**ACE/ATRIUM 11 Critical Power
Correlation**

ANP-10335NP-A
Revision 0

SUBJECT: FINAL SAFETY EVALUATION FOR FRAMATOME INC. TOPICAL REPORT
ANP-10335P, REVISION 0, "ACE/ATRIUM 11 CRITICAL POWER
CORRELATION" (CAC NO. MF5841; EPID L-2015-TOP-0002)

FINAL SAFETY EVALUATION BY THE OFFICE OF NUCLEAR REACTOR REGULATION

Figure 1. KATHY Thermal-hydraulic Test Loop

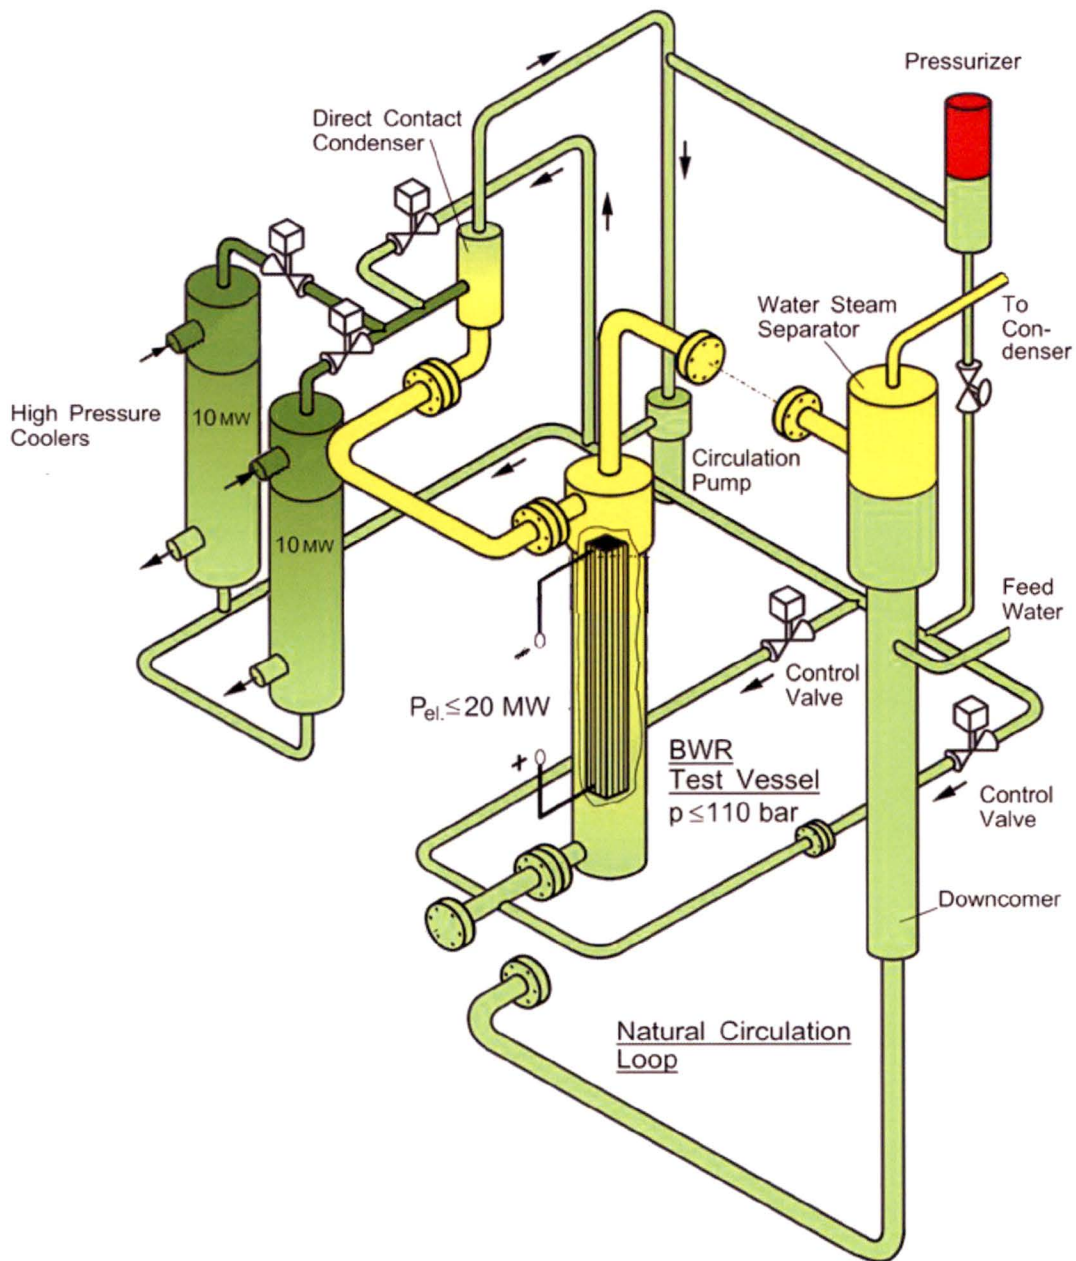
Question 1:

All of the data for the ACE/ATRIUM 11 critical power correlation were taken at the AREVA KATHY thermal-hydraulic test loop located in Karlstein, Germany. Figure 1 shows that the thermal hydraulic test facility is a high pressure water heat transfer loop containing a test vessel (shown in Figure 2) with the test assembly and upper and lower bus bars, high pressure coolers, a direct contact condenser, an electrically heated pressurizer, and the main circulation pumps. Two inlet flow lines of different sizes are shown. The different sizes allow fine control of the flow rate over a broad range. The test loop is rated at [] The DC power supply consists of four thyristor controlled rectifiers, providing a total electrical current of []
